SB TMG 601-1007 P1, Rev. 5

SERVICE BULLETIN

Subject: Start Monitoring Loom and Mapping

Type affected: All Cessna C172 (Reims F172) with TAE 125-02 and Dual Mass Flywheel (DMF)

Figure 1a

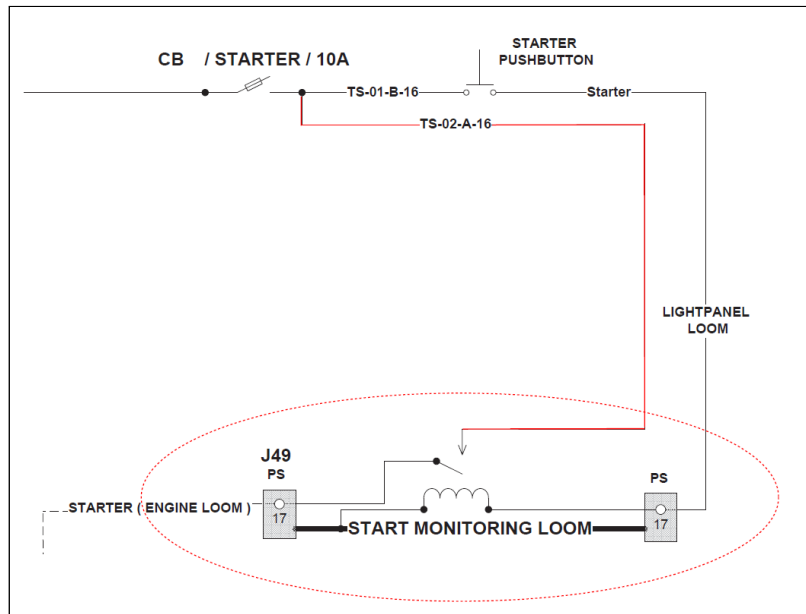
- Install the appropriate start monitoring loom behind the cockpit panel between light panel loom and engine loom in accordance with Figure 1a.

- Attach the start monitoring loom along existing cable bundles.
- Connect the main, excitation and FADEC backup battery.
- Install the new engine firmware TAE-125m3.30 (D48 FADEC) resp. D4-140 (D4 FADEC) or later version plus A/C related mapping. See TM TAE 000-0007.
